DESCRIPTION AND SAFETY ANALYSIS  
OF PROPOSED CHANGE NPF-10/15-200

This is a request to revise Technical Specification (TS) 3/4.1.2.1, "Boration Systems - Flow Path - Shutdown," TS 3/4.1.2.2, "Boration System - Flow Paths - Operating," TS 3/4.1.2.6, "Boric Acid Makeup Pumps - Operating," TS 3/4.1.2.7, "Borated Water Source - Shutdown," TS 3/4.1.2.8, "Borated Water Source - Operating," TS 3/4.5.1, "Safety Injection Tanks," TS 3/4.5.4, "Refueling Water Storage Tank," and Associated Bases.

## DESCRIPTION OF PROPOSED CHANGE NPF-10/15-201 AND SAFETY ANALYSIS

This is a request to revise Technical Specification 3/4.2.4, "DNBR Margin", and 3/4.3.1, "Reactor Protective Instrumentation", and their associated bases.

FIGURE 3.2-2 DNBR OPERATING LIMIT BASED  
 ON CORE PROTECTION CALCULATOR  
 - COLSS OUT OF SERVICE  
 - BOTH CEACS INOPERABLE

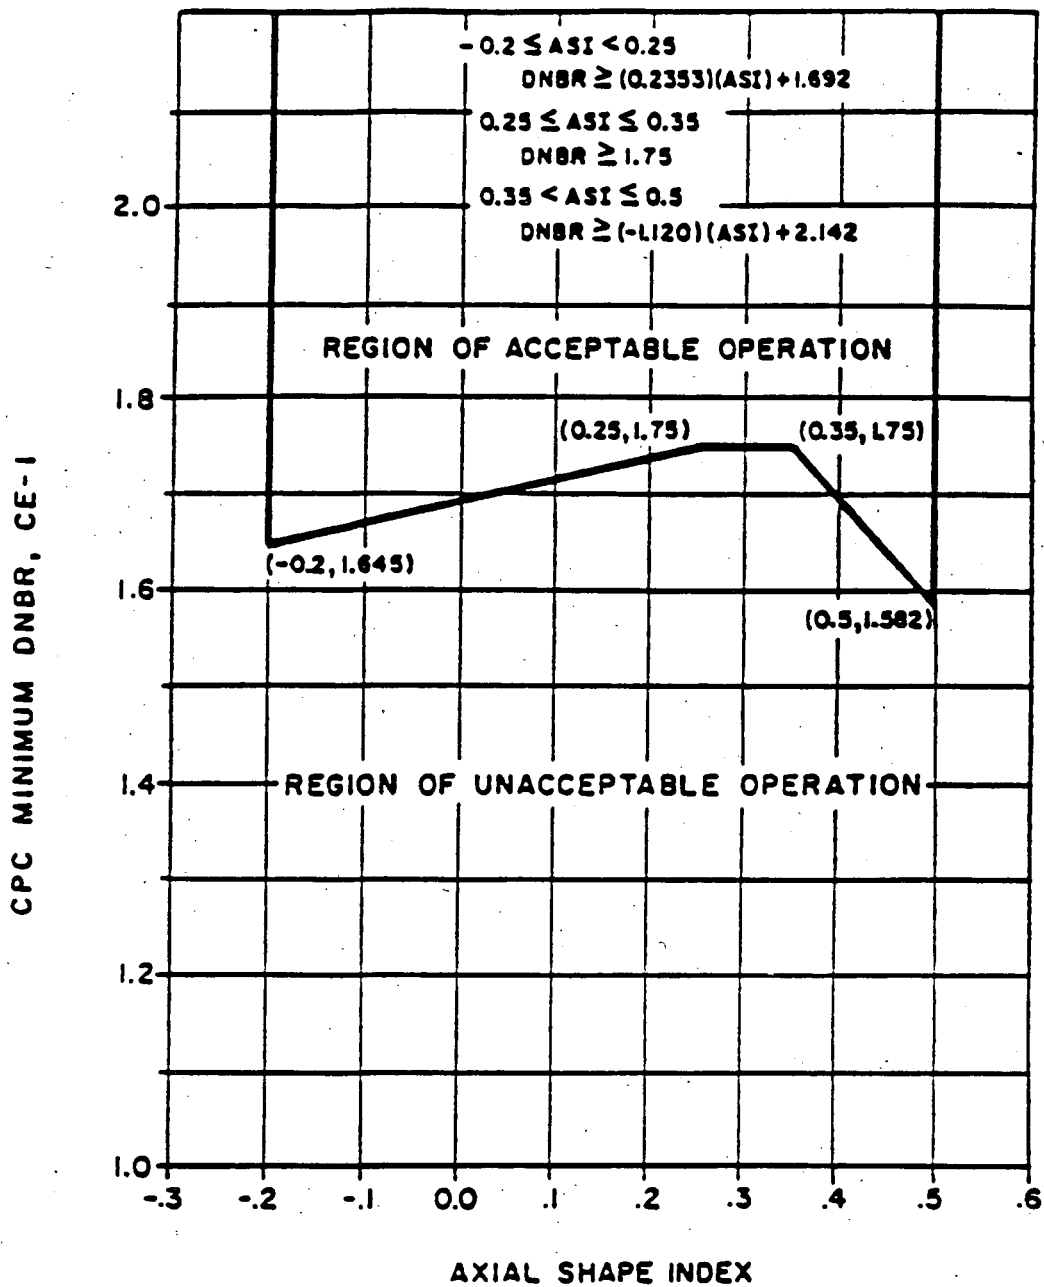
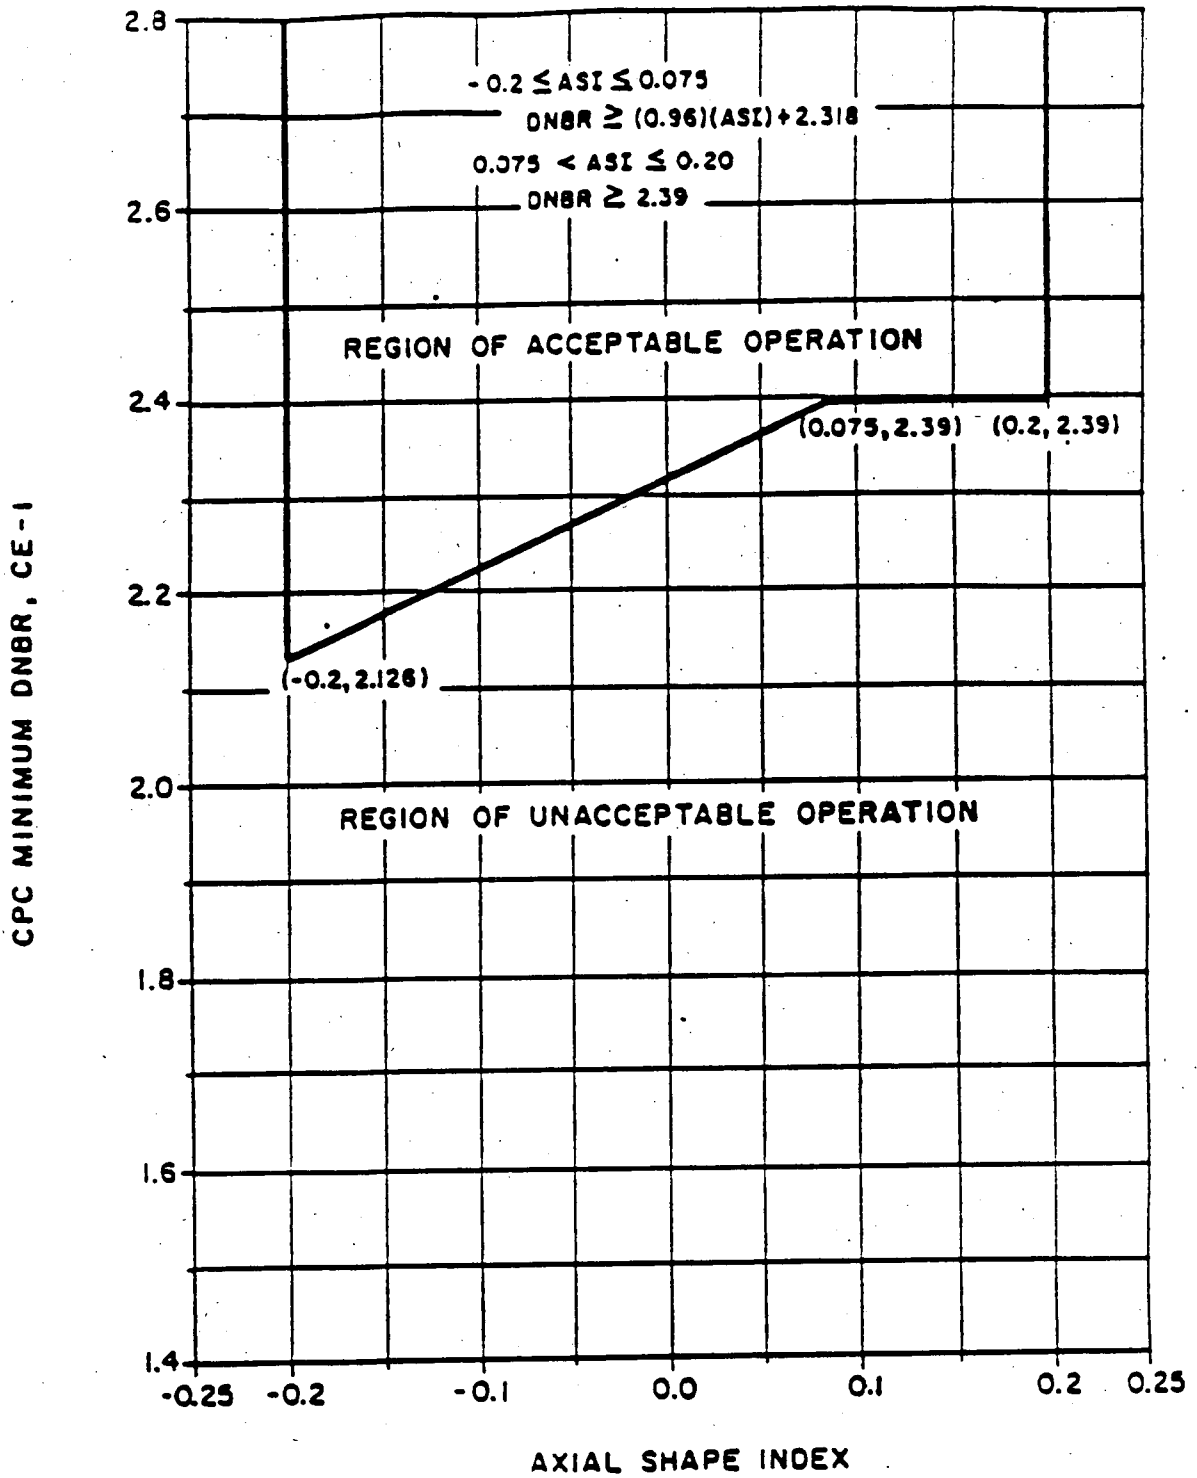
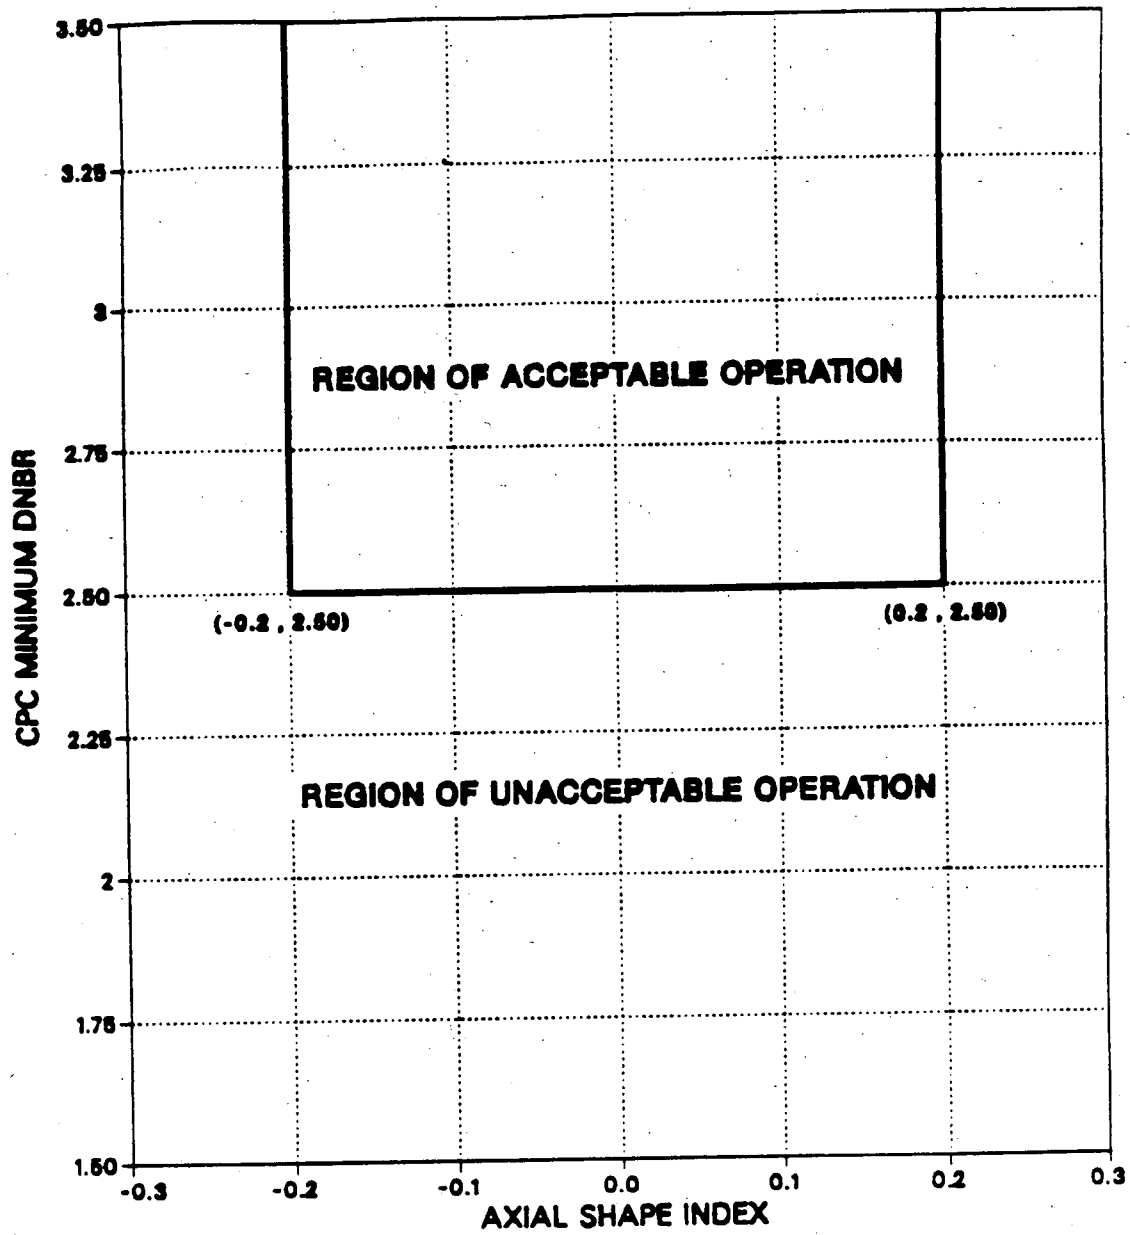
- a) The proposed change revises Figures 3.2-1, "DNBR Operating Limit Based on COLSS", Figure 3.2-2, "DNBR Margin Operating Limit Based on Core Protection Calculators (COLSS out of service, with power greater than or equal to 80% of rated thermal power)", and Figure 3.2-3, "DNBR Margin Operating Limit Based on Core Protection Calculators (COLSS out of service, with power less than 80% of rated thermal power)". Specifically, Figure 3.2-1 shows the minimum calculated Power Operating Limit (POL) based on DNBR for a given reactor power level. Provided that the COLSS POL is greater than that required by Figure 3.2-1 for a given reactor power, the plant is operating in the region of acceptable operation. The existing Figure 3.2-2 defines the required minimum DNBR margin for reactor operation at greater than or equal to 80% power. Figure 3.2-3 defines the required minimum DNBR margin for reactor operation at less than 80% power. The proposed change to Technical Specification 3.2.4 replaces the existing Limiting Condition for Operation (LCO) with four parts, 3.2.4.a through 3.2.4.d. 3.2.4.a and 3.2.4.b replace the existing Figure 3.2-1 with words to the same effect.

3.2.4.a and 3.2.4.b replace the existing Figures 3.2-1 with words to the same effect when COLSS is in service. Additionally, both new figures supplant the existing Figures 3.2-2 and 3.2-3 in compliance with 3.2.4.c and 3.2.4.d when COLSS is out of service. Thus, DNBR will be maintained by 3.2.4.a (or 3.2.4.c) when either one or both CEAC are operable and by 3.2.4.b (or 3.2.4.d) when neither CEAC is operable. Since the proposed change pertains to a revision of graphic representations in LCO with a set of plain administrative control statements easy for understanding and two consolidated figures for simplification, it is a change within the scope contemplated by Example (1).
